CASE / FORD NEW HOLLAND - Serie 40 & 10

Art.nr. 3482 600 105

MF 330

Fig. 1: 330 mm enkel med membranfjæring clutch

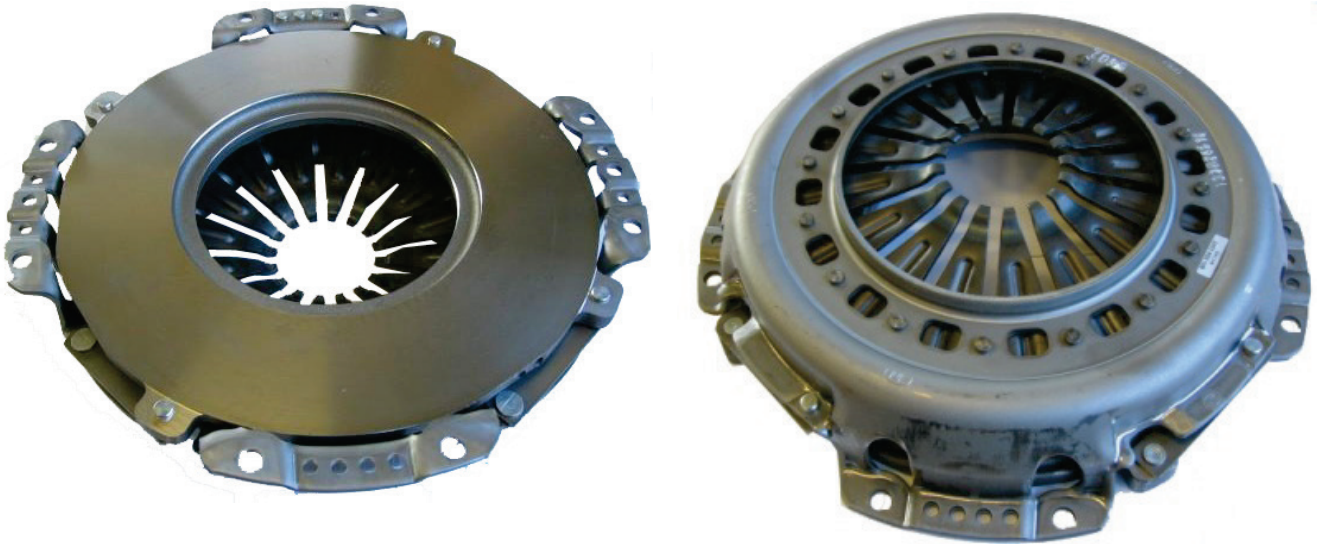
Når de 4 spak skruefjær clutchene byttes ut mot en SACHS membranfjæring clutch, bortfaller segmentplatene.

SACHS membranfjæring clutchen må kun monteres sammen med en SACHS clutchskive (se tabell).
